**CERTIFICATE OF APPROPRIATENESS**

**RE: Application Number 20-6777; 1441 Brooklyn Street, Corktown Historic District**

Permits	
06/19/20	BZA Submission
06/18/20	Historic Commission Review
06/08/20	Owner Review
Date:	Issued For:
<b>Kaul Glove Building Renovation &amp; Adaptive Reuse</b>	
1441 Brooklyn Detroit, Michigan 48226	
<b>studiozONE : DETROIT</b>	
architectural urban interior	DESIGN
330 Madison Avenue 4th Floor Detroit, Michigan 48226	studiozonedetroit.com 313.549.2790 [p] jgb@ware-house.com

**EXISTING ROOF PLAN**

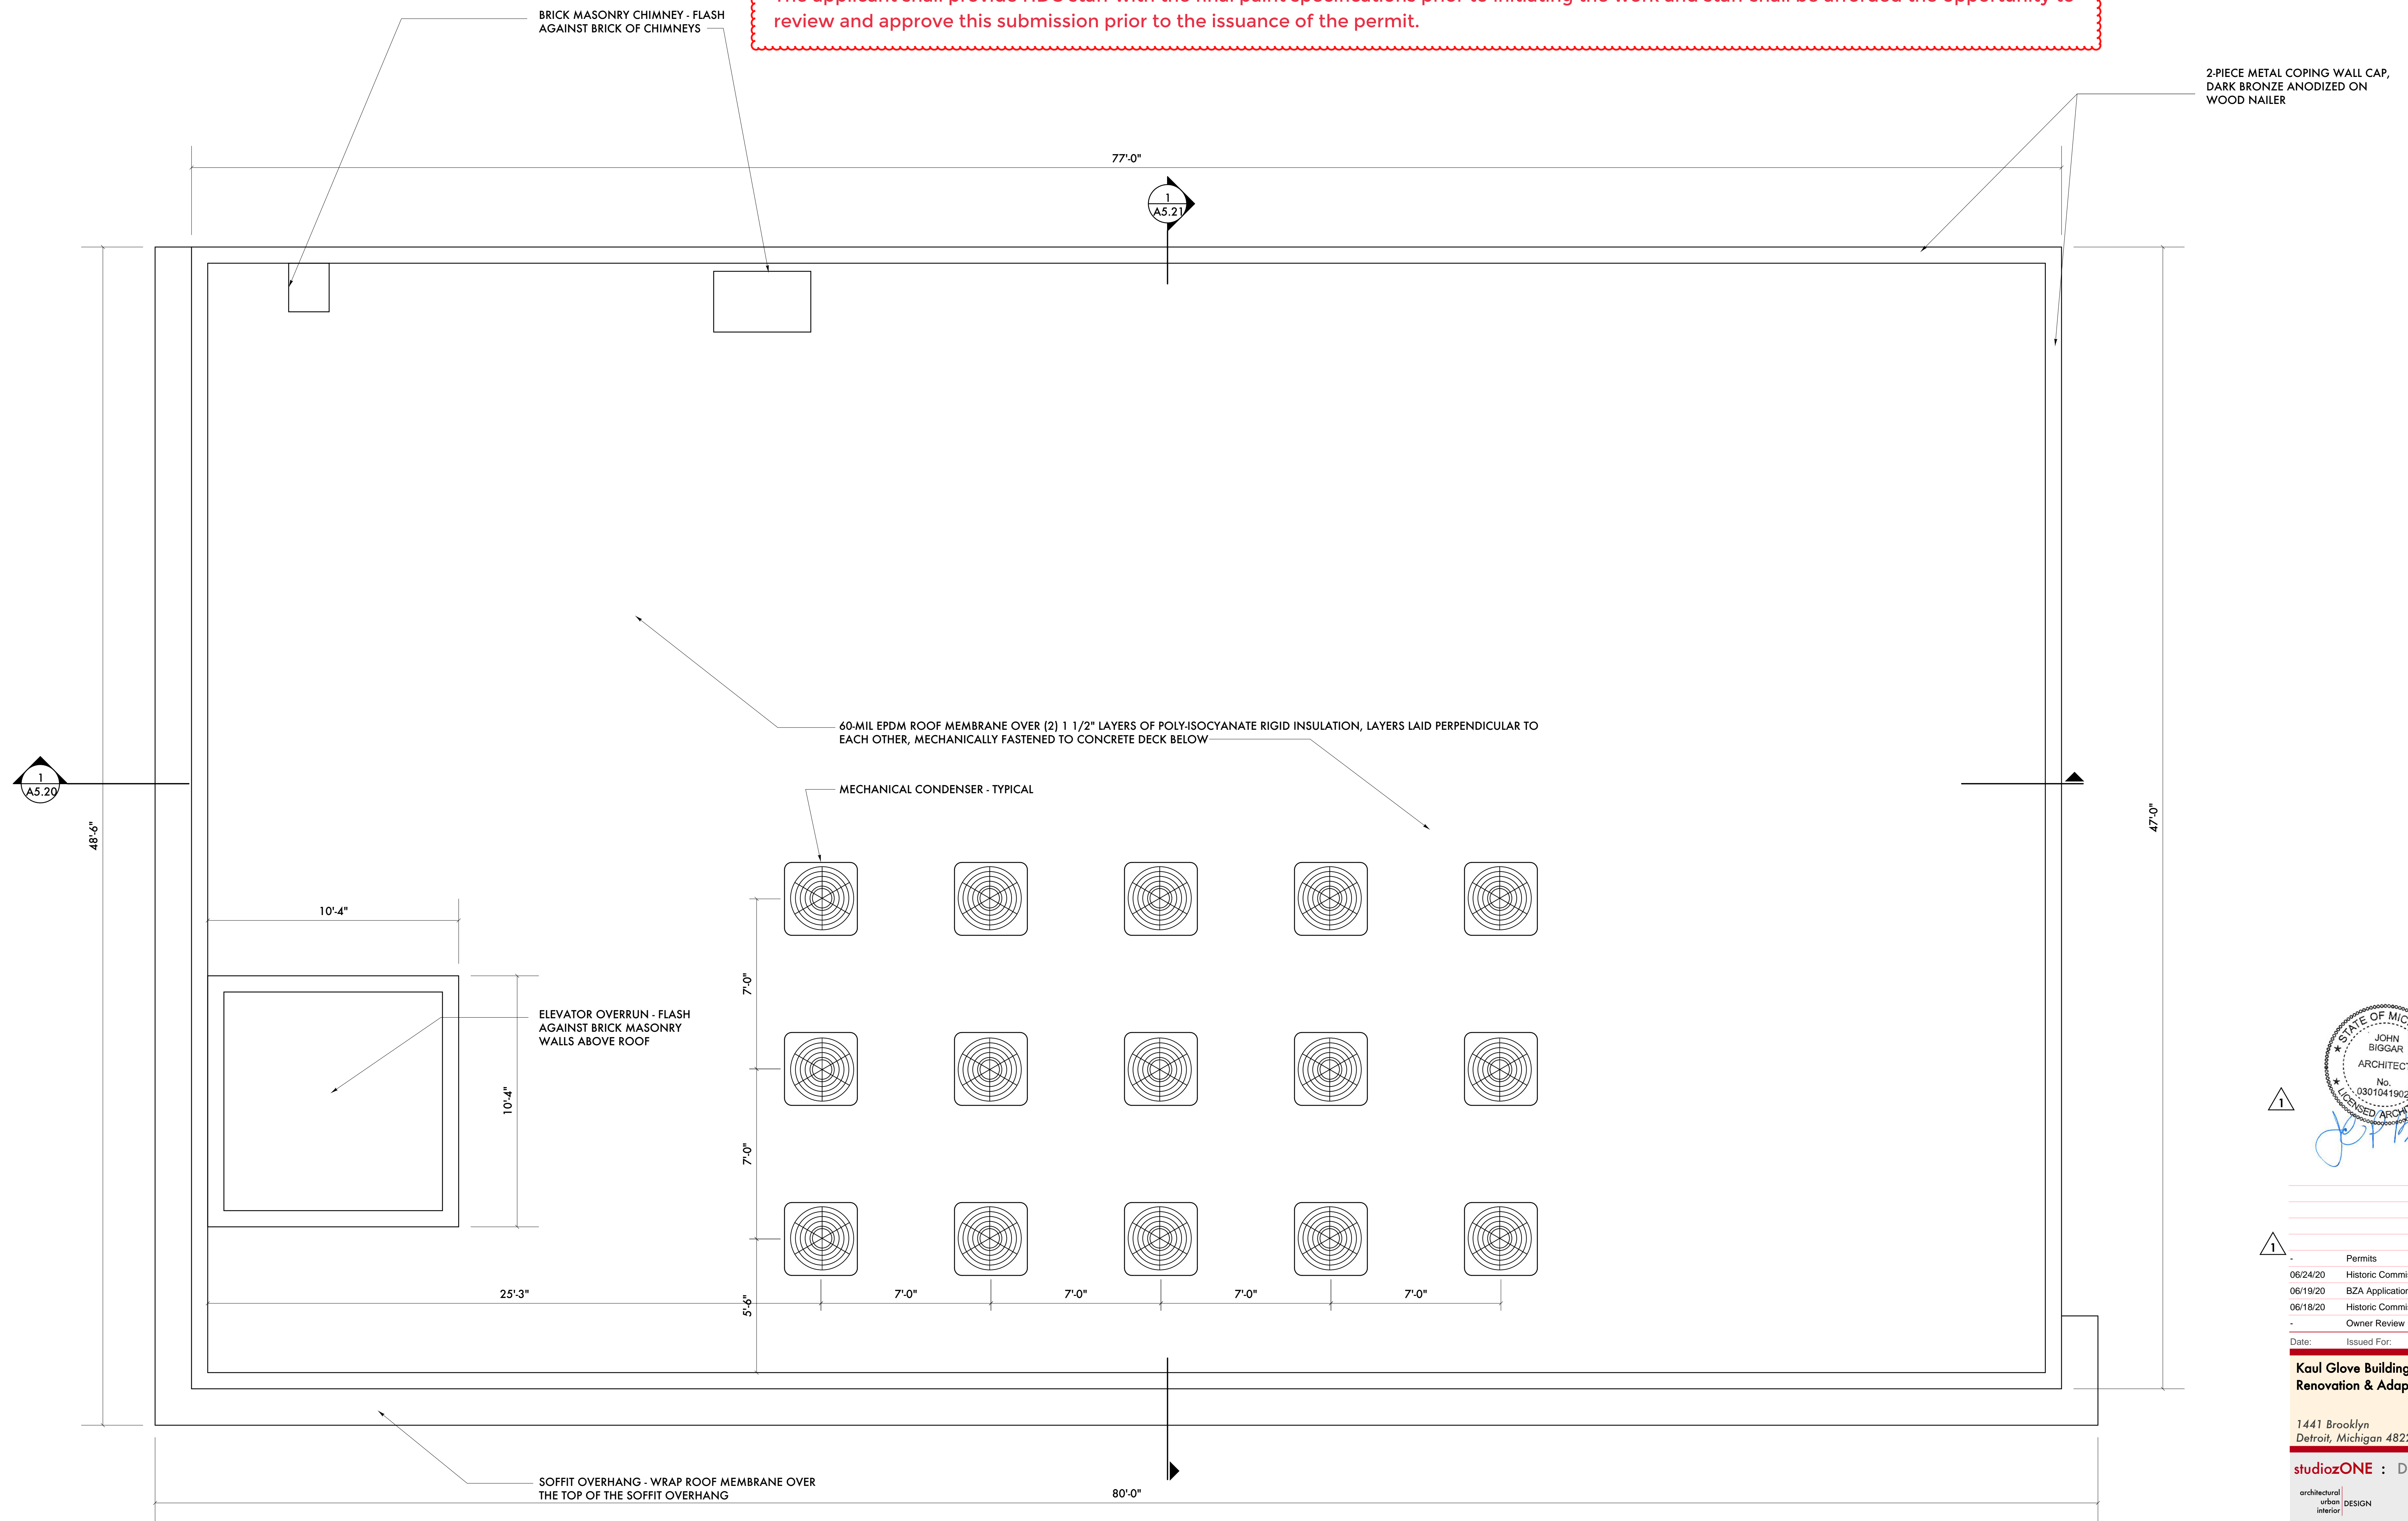
- Replace existing roofing surface with new EPDM roof membrane.
  - Install (15) new mechanical condenser units centered on the east half of the roof. Existing parapet wall to hide condenser units.

**A BROOKLYN ELEVATION (EAST)**  
SCALE: 3/8" = 1 - 0"  
0' 1' 2' 4' 10' 16'

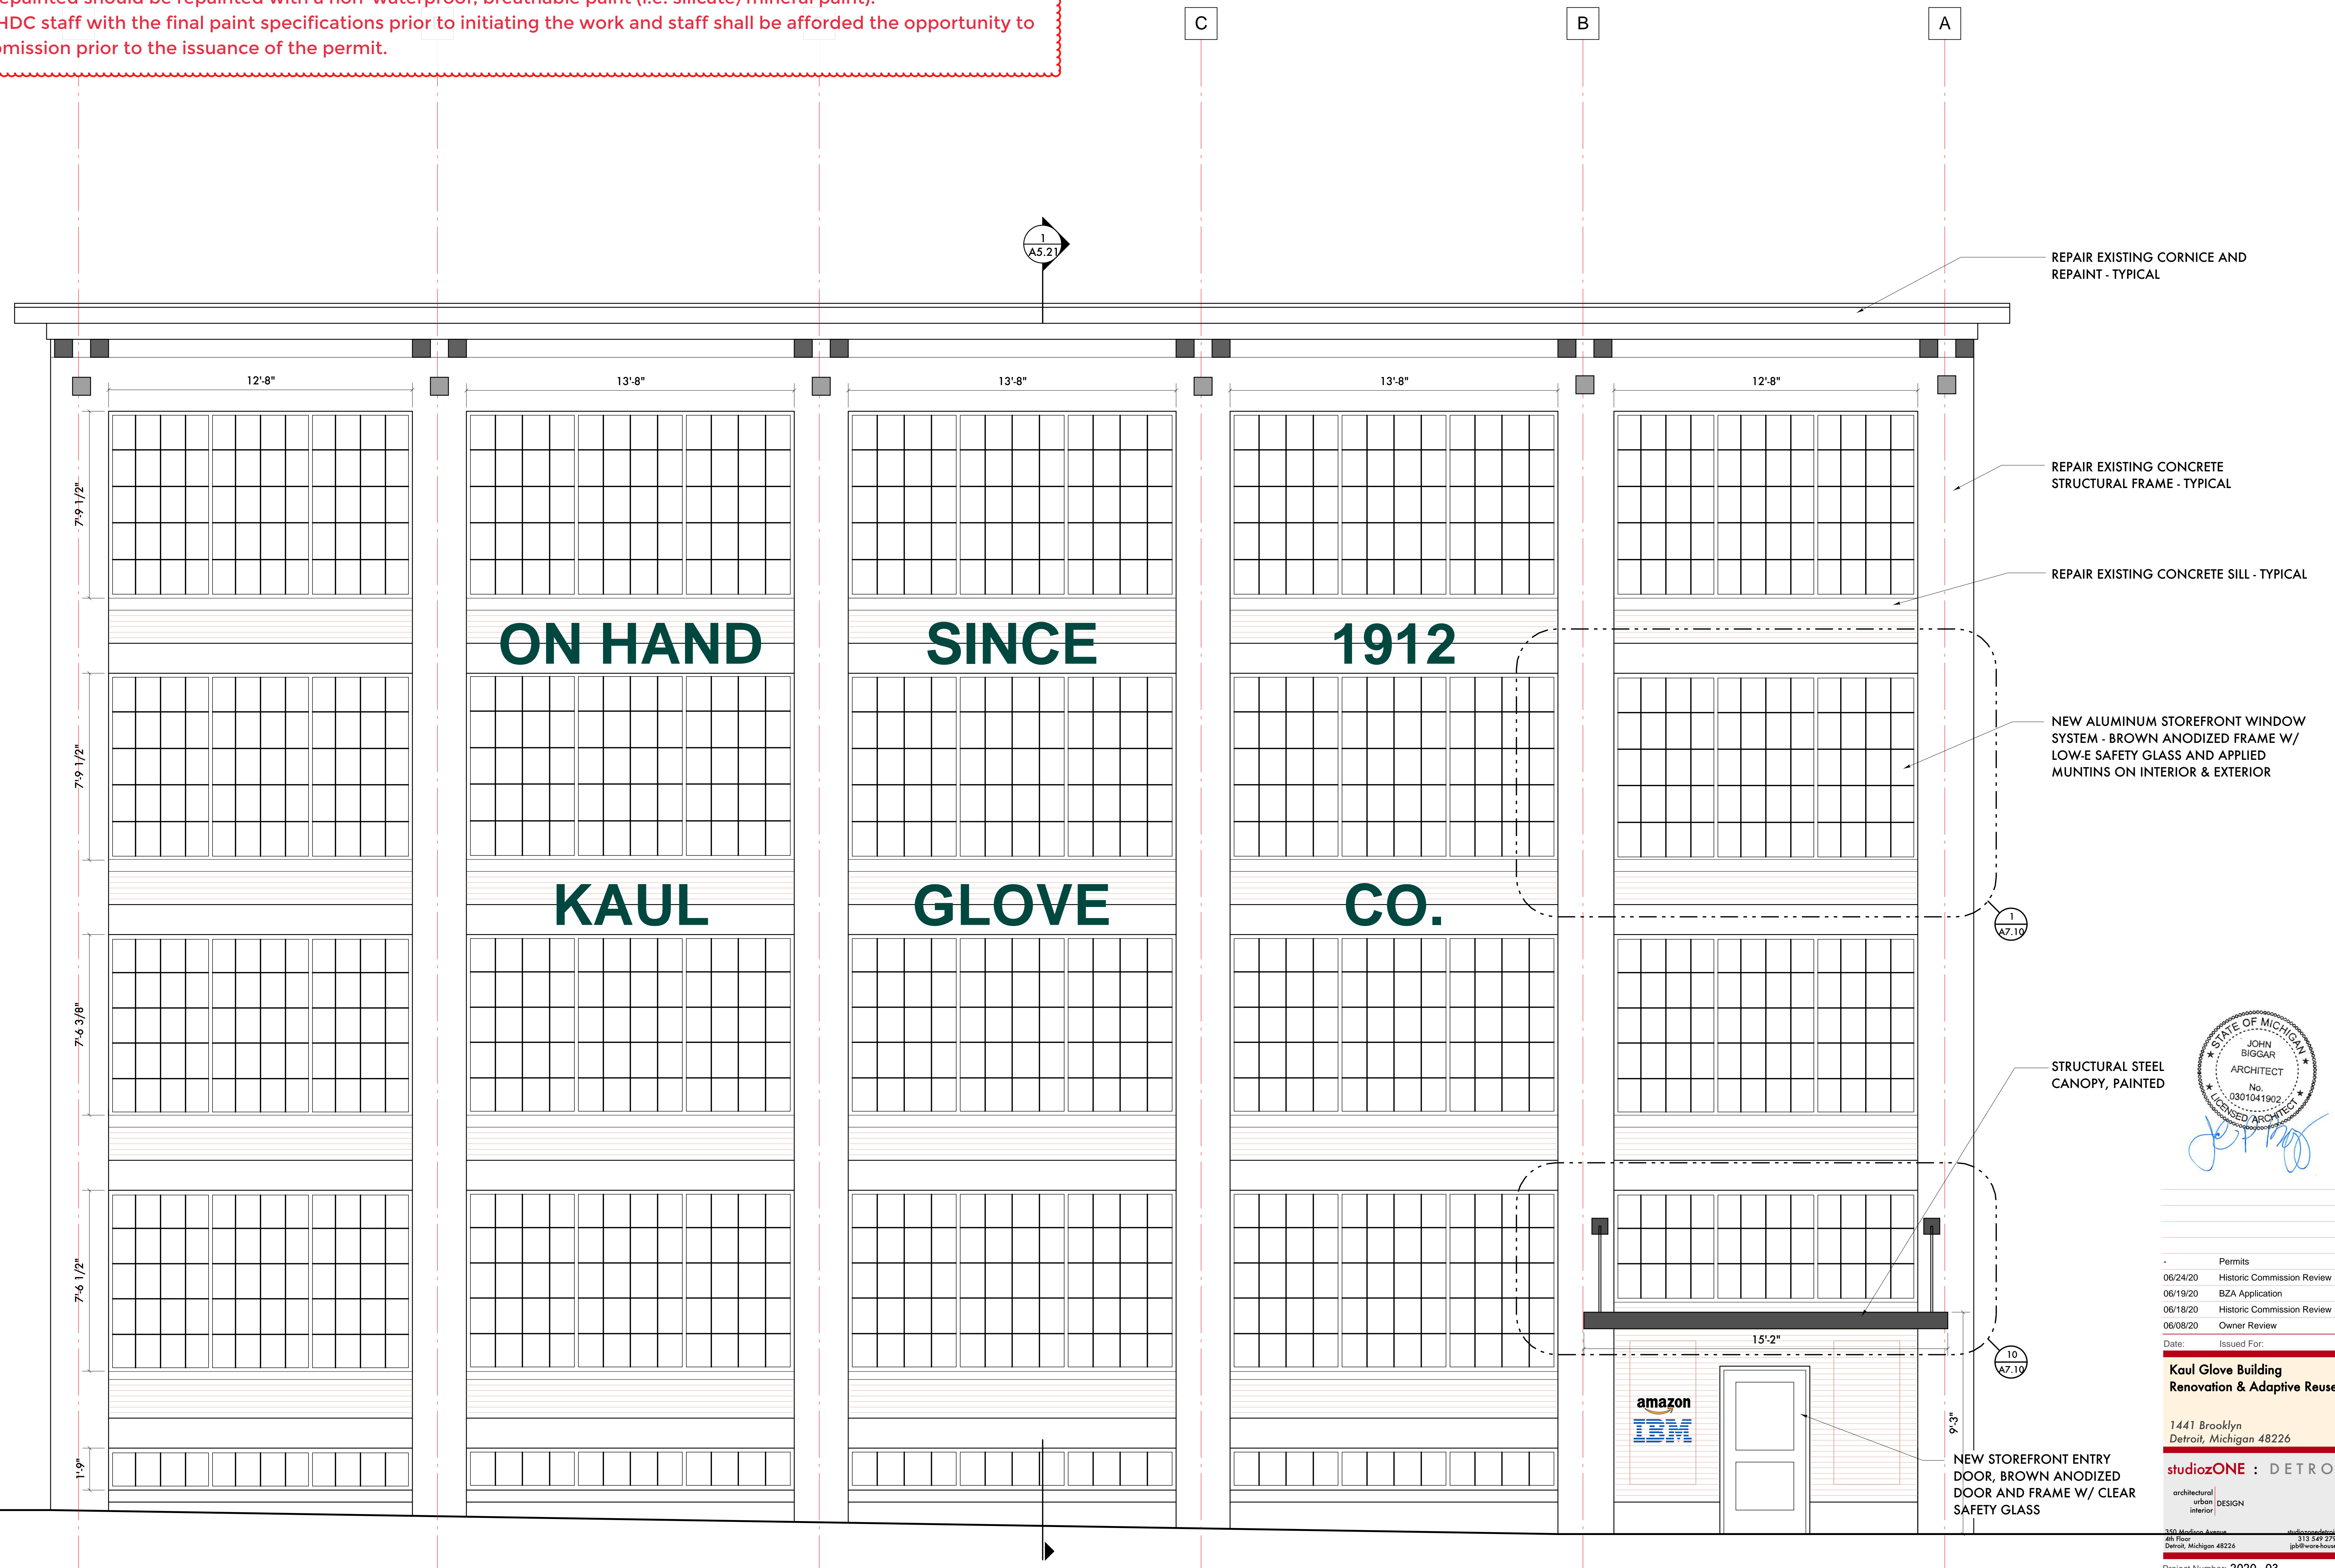
- **Perform a general rehabilitation of the building including new windows throughout the building. The scope of work includes:**
  - Remove existing glass block and brick infill and any existing windows at original openings and replace with new aluminum storefront window systems (color: brown anodized) in the majority of the structural frame openings. See drawings for locations. Storefront systems will be fixed with no operable windows. Mullion and muntin (externally applied) pattern to match the configuration of the original windows.

- Signage on Brooklyn Street (east) elevation which reads “ON HAND SINCE 1912” and “KAUL GLOVE CO.” is to remain.
  - Remove existing awning and door at northernmost bay of Brooklyn Street (east) elevation and replace with new aluminum storefront entry door (color: brown anodized) and frame with clear safety glass and new structural steel canopy. Canopy to attach to face of existing masonry with 10” x 10” steel plates and ¾” rods. It is to be 15’-2” wide by 4’-0” deep and painted to match brown anodized color of storefront system. (3) recessed downlights are included in the canopy.
